**RELICENSING STUDY 3.3.8**

**COMPUTATIONAL FLUID  
DYNAMICS MODELING IN THE  
VICINITY OF THE FISHWAY  
ENTRANCES AND POWERHOUSE  
FOREBAYS**

**ADDENDUM**

**Northfield Mountain Pumped Storage Project (No. 2485)  
and Turners Falls Hydroelectric Project (No. 1889)**

Figure 2.4-6: Station No. 1 Scenario 1-3 Forebay Particle Trace Plots

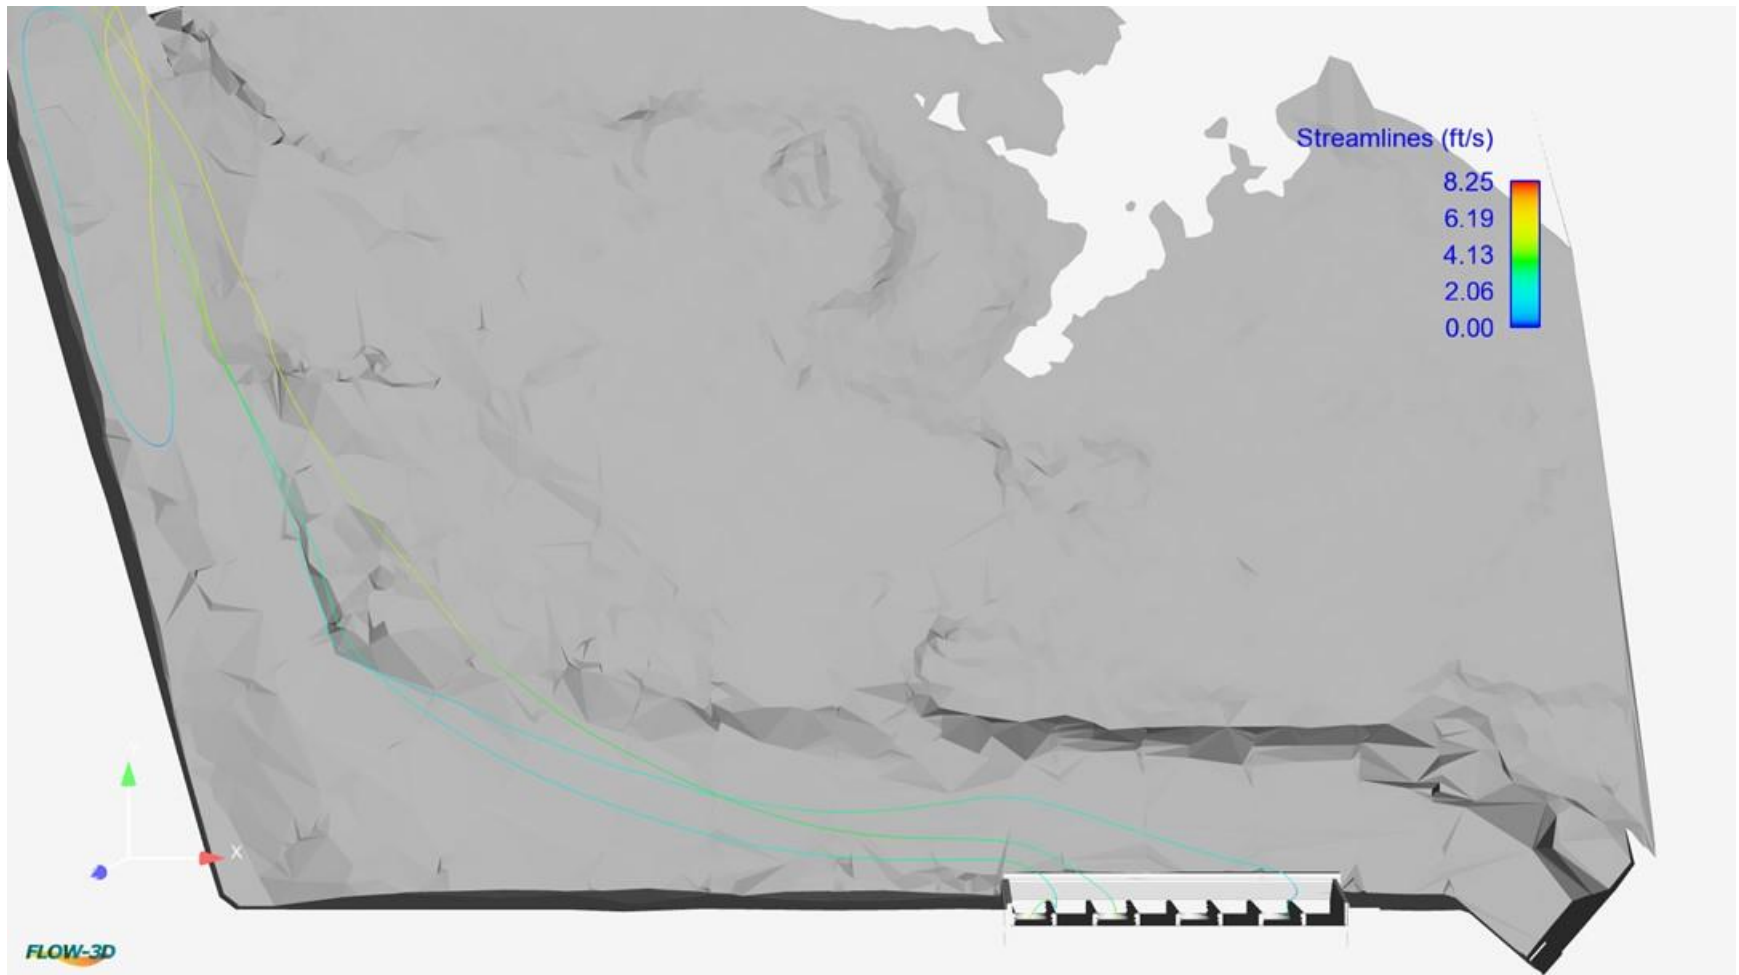
Comment: *To help us better understand the entrainment potential of juvenile alosines, we request that FL produce particle trace plots showing a similar perspective as the flow vector plots in figures 8.2.1-1, 8.2.1-2, 8.2.1-3, 8.2.2-1, 8.2.2-2, 8.2.2-3, 8.2.3-1, 8.2.3-2, and 8.2.3-3. If possible, for clarity, please include at least five seeds in each particle trace plot. It is our understanding that generating these plots will not necessitate new production runs. Relative to the Cabot Intake overview plots.... Similar to the above request, we request that FL produce particle trace plots similar to figures 8.3.1-1, 8.3.1-2, 8.3.2-1, 8.3.2-2, 8.3.3-1 and 8.3.3-2 for the Station No. 1 intake. If possible, for clarity, please include at least five seeds in each particle trace plot. It is our understanding that generating these plots will not necessitate new production runs.*

Particle trace plots for the flows in the Station No. 1 Power Canal and Forebay under Scenario 1-1 are shown in [Figures 2.4-1](#) and [2.4-2](#), respectively. Particle trace plots for the Station No. 1 Power Canal and Forebay under Scenario 1-2 are shown in [Figures 2.4-3](#) and [2.4-4](#), respectively. Particle trace plots for the Station No. 1 Power Canal and Forebay under Scenario 1-3 are shown in [Figures 2.4-5](#) and [2.4-6](#), respectively.

**Figure 2.9-1: Cabot Fishway supplemental ADCP data.**

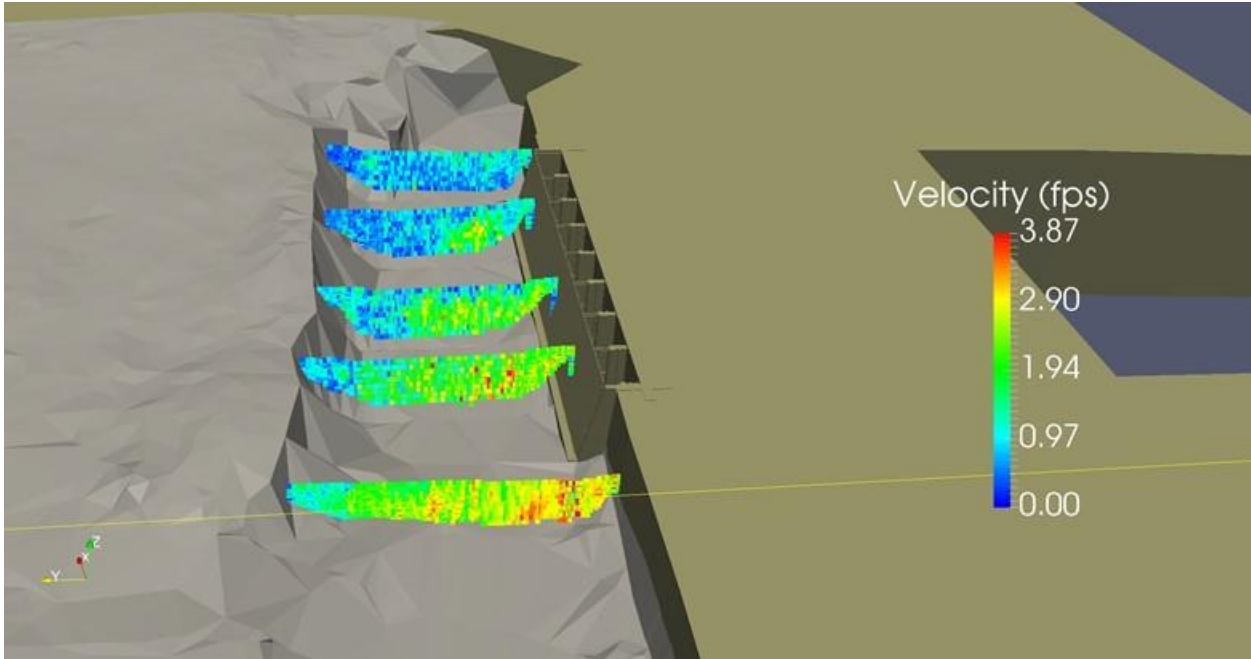
Comment: *Add text to clarify the extent/scope of this data. The report should make it clear whether the data consisted only of bathymetric survey point or if additional ADCP velocity measurements were also collected. What were the flow conditions in the river during this supplemental data collection? Can the collected ADCP data from Study No. 3.3.1 be used as another verification run?*

Of those dates, only the 7/23/2014 data is collected at a flow that is substantially different than the existing validation run. [Figure 2.9-1](#) shows the approximate location of the supplemental ADCP data, as well as which data points may be used for velocity data.

**Figure 2.12-1: Station 1 Verification of Measured ADCP (top) and Simulated Flow-3D (bottom) Water Velocities**

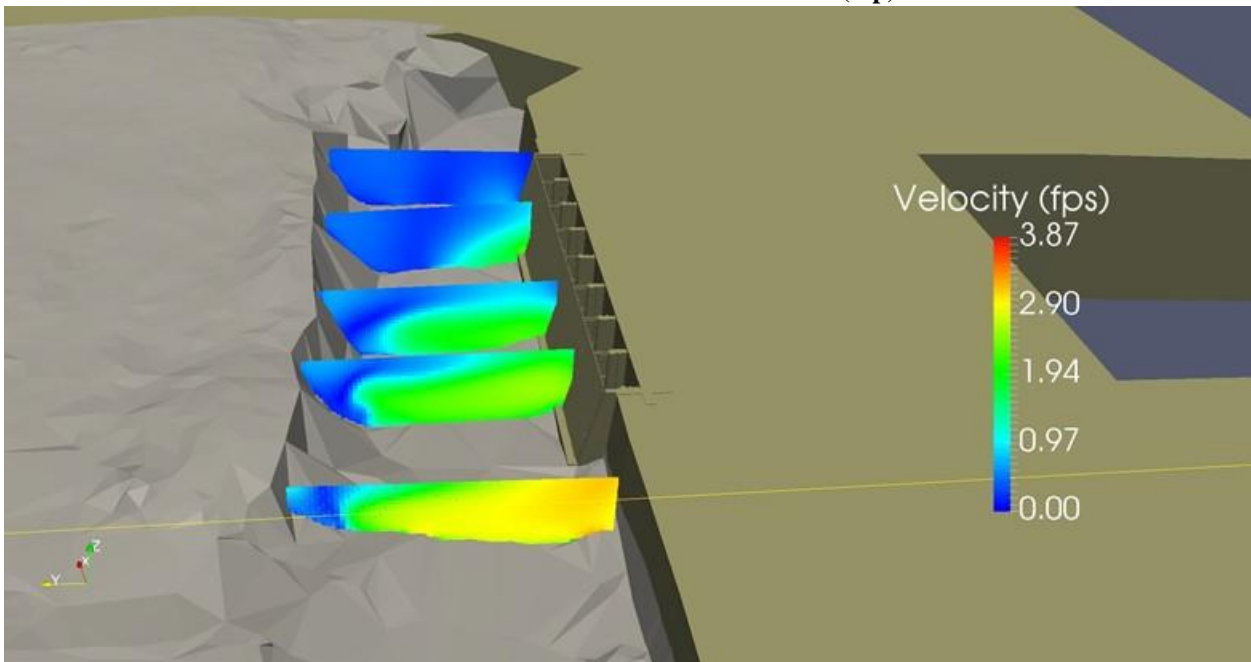
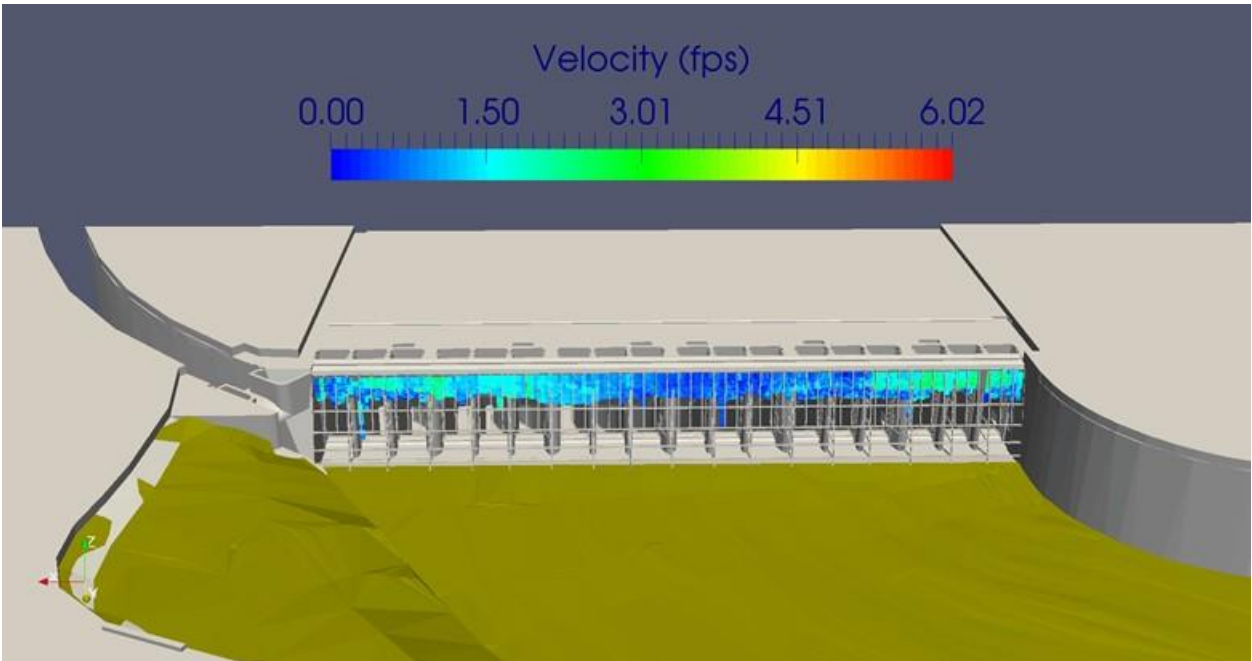
Comment: [The report's] page 6-2, sixth paragraph states: *Based on a comparison of the ADCP and CFD model results it is believed that the results from the CFD model production runs are appropriate for meeting the objectives of this study.*

[Figure 2.12-1](#) shows the observed (ADCP) velocities for the verification run at Station 1 (top), and the simulated (CFD model) velocities for the same location (bottom).

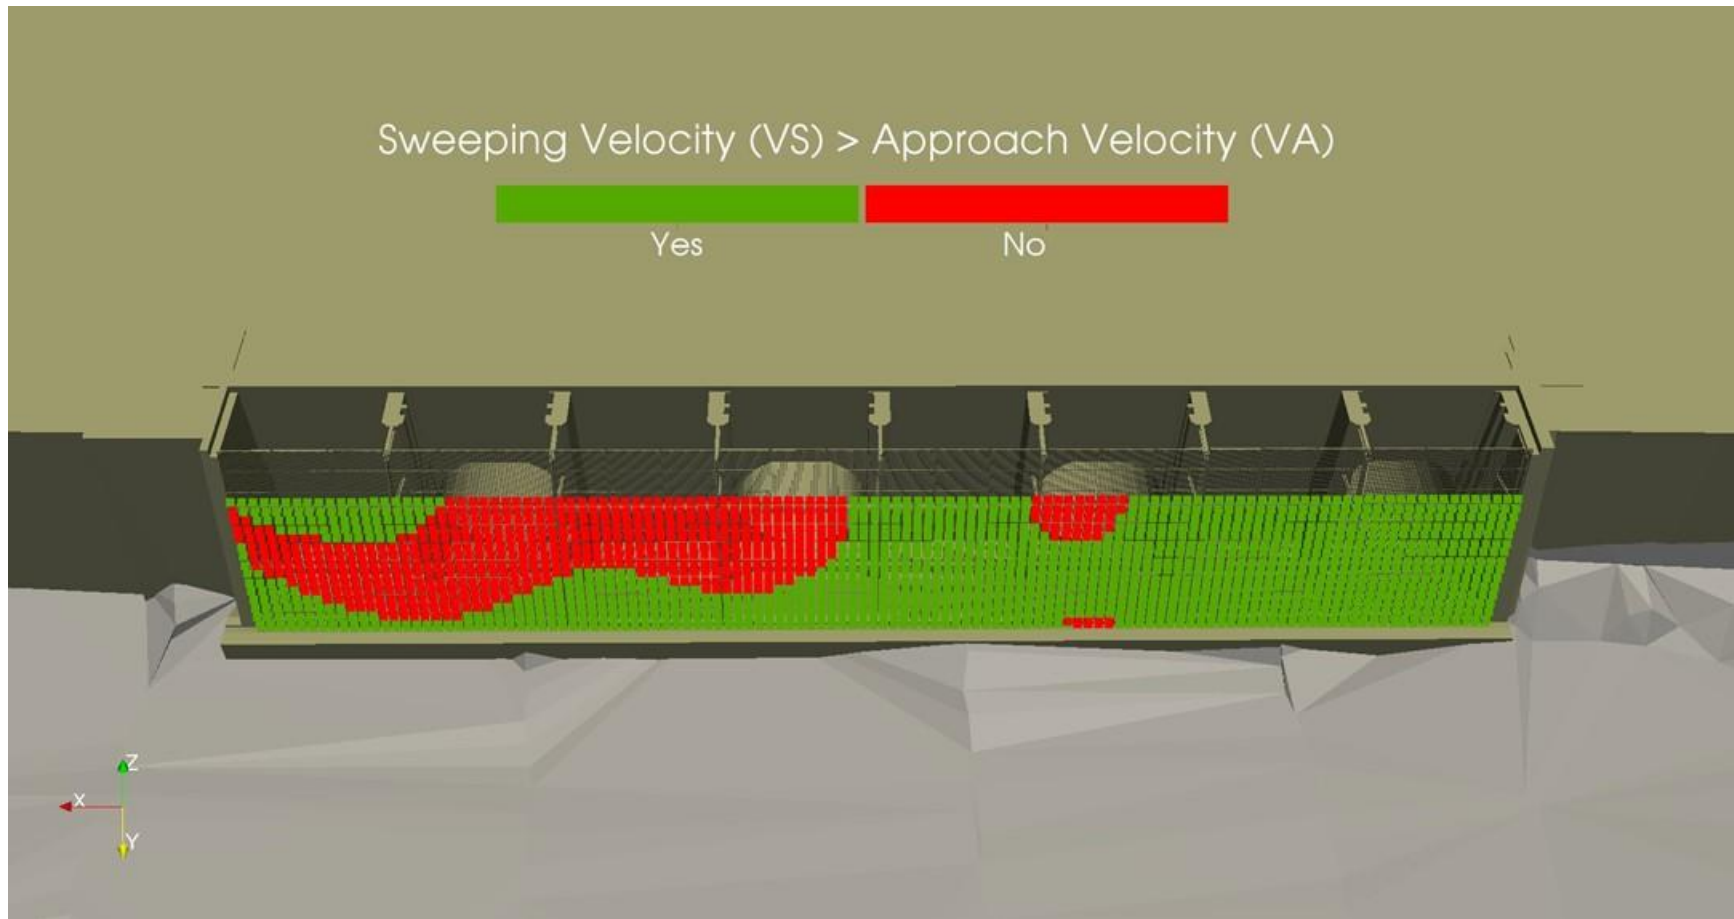
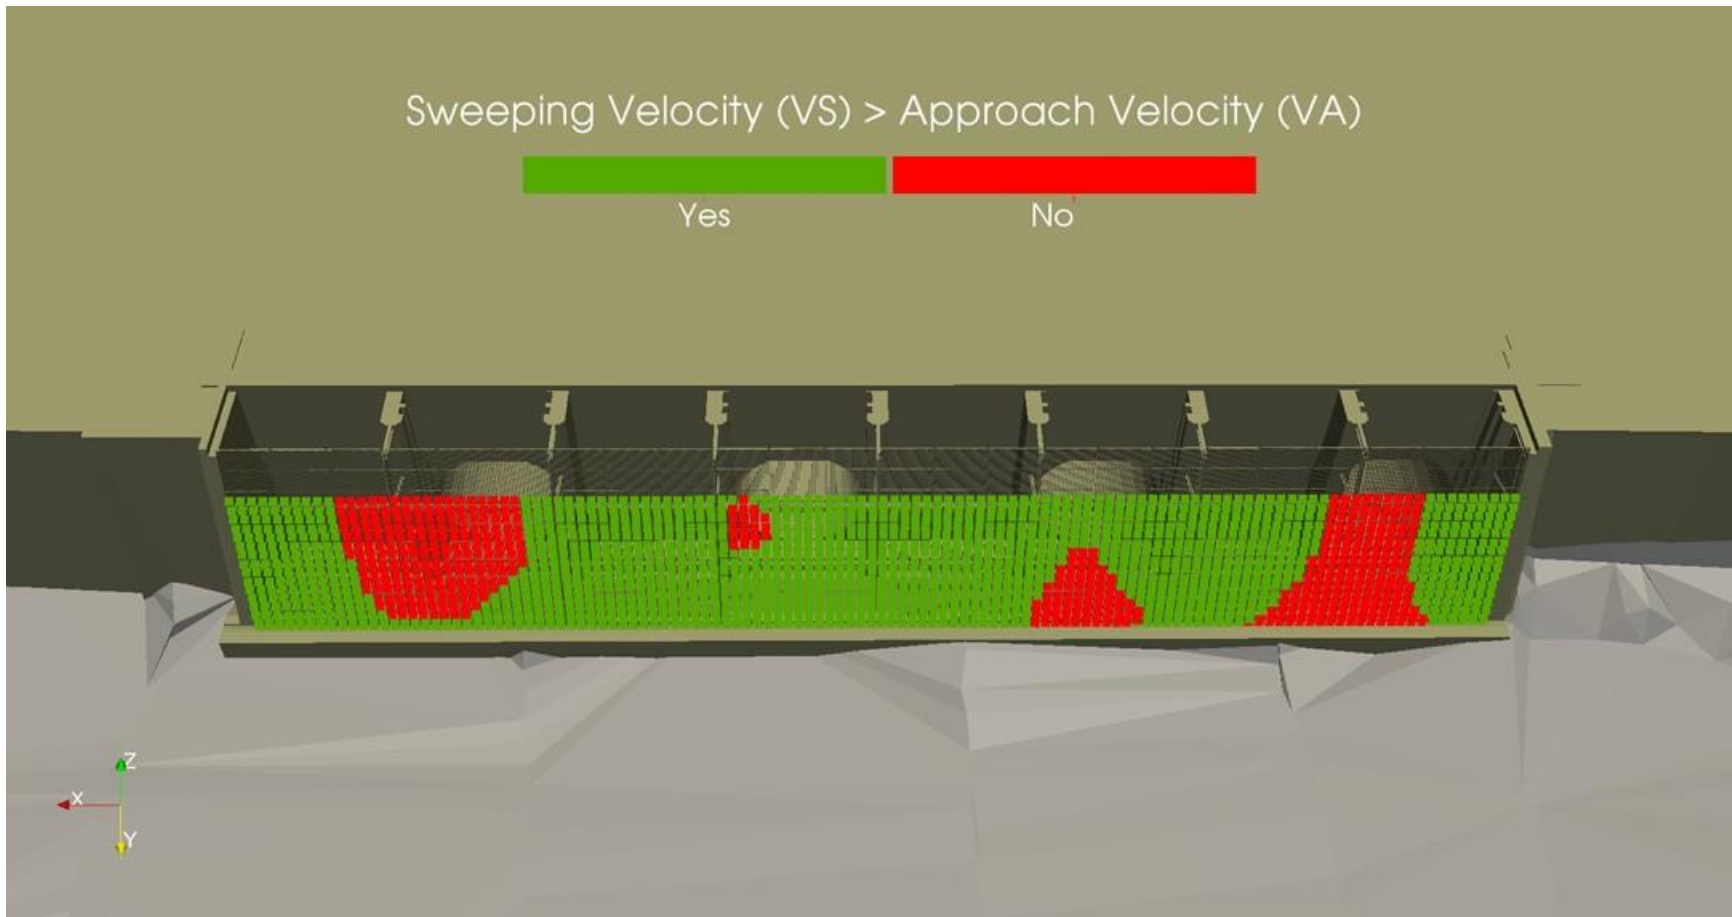
Comment: For Figures 8.2.1-4 to 8.2.1-6; Figures 8.2.2-4 to 8.2.2-6; and Figures 8.2.3-4 to 8.2.3-6: Include additional intake rack figures to display component velocity. For figures showing approach velocity, the scale should have a maximum of 2 fps such that all approach velocities exceeding 2 fps are red. For figures showing the sweeping velocity, the color scale should be binary such that  $VS > VA$  is green and  $VS \leq VA$  is red. The sweeping velocity figures should show directionality.

Additional plots showing the component velocity (VS and VA) comparison in front of the intake racks with a binary color scheme such that  $VS > VA$  is green and  $VS \leq VA$  is red were generated for Scenarios 1-1, 1-2 and 1-3. [Figure 2.14-1](#) shows the component velocity comparison for Scenario 1-1, [Figure 2.14-2](#) shows the component velocity comparison for Scenario 1-2, and [Figure 2.14-3](#) shows the component velocity comparison for Scenario 1-3.
